# FISH PASSAGE CENTER

## MEMORANDUM

RE: Review Performance Standard Testing/ John Day 2010

RE: Review of Acoustic Telemetry Evaluation of Juvenile Salmonid Passage at John Day Dam, 2009 Draft Final Report

Figure 3.29. Spill treatments as prescribed (red line) and actual conditions (black line) in spring (repeated from Figure 3.22 for ease of reference)

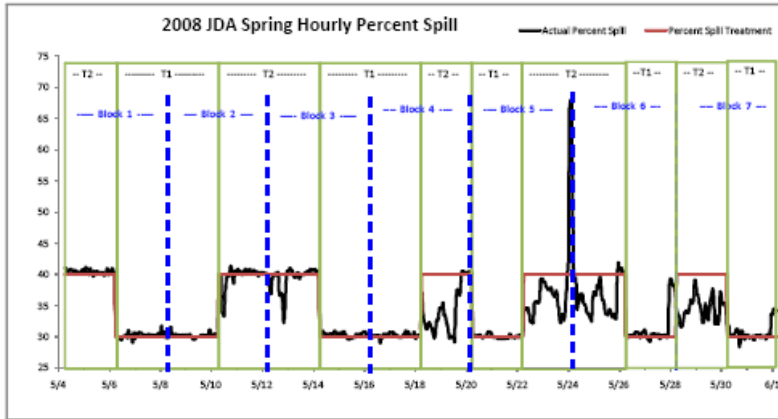
Based on our review of the PNNL 2008 acoustic telemetry study it is difficult to determine how the steelhead survival estimates were grouped to arrive at the numbers reported both in the PNNL 2008 report to the COE and in the Weiland et al. presentation to AFEP 2010. In both the 2008 report and the 2010 presentation by PNNL the paired steelhead survivals in 2008 were 99.1% for the 30% spill treatment and 97.2% for the 40% spill treatments. However, upon using the average survival for the virtual release blocks from the appendices of the 2008 report and the date blocks identified in Figure 3.29 from 2008 PNNL report, we estimated the paired release survival at were 99.0% for the 40% nominal spill treatment group when we took a simple average of the survival blocks, while the 30% group average survival was 97.7%. We also considered sample size weighted average estimates and found the same pattern; with the 40% spill test having a 99.2% average survival compared to 97.8% average for the 30% tests. Finally, we also pooled detection tallies for all blocks within each treatment and estimated a paired release survivals of 98.6% for the 40% treatment blocks compared to 97.6% for the 30% blocks. Our results are the opposite of what PNNL is reporting and lends confusion to the consideration and application of these results to operations decisions. In all of the methods we used to combine the data; the 40% blocks appeared to have higher survival than the 30% blocks, which is opposite of what was reported in the PNNL reports.

Figure 3.29 of the PNNL final 2008 report to the COE on JDA survival.
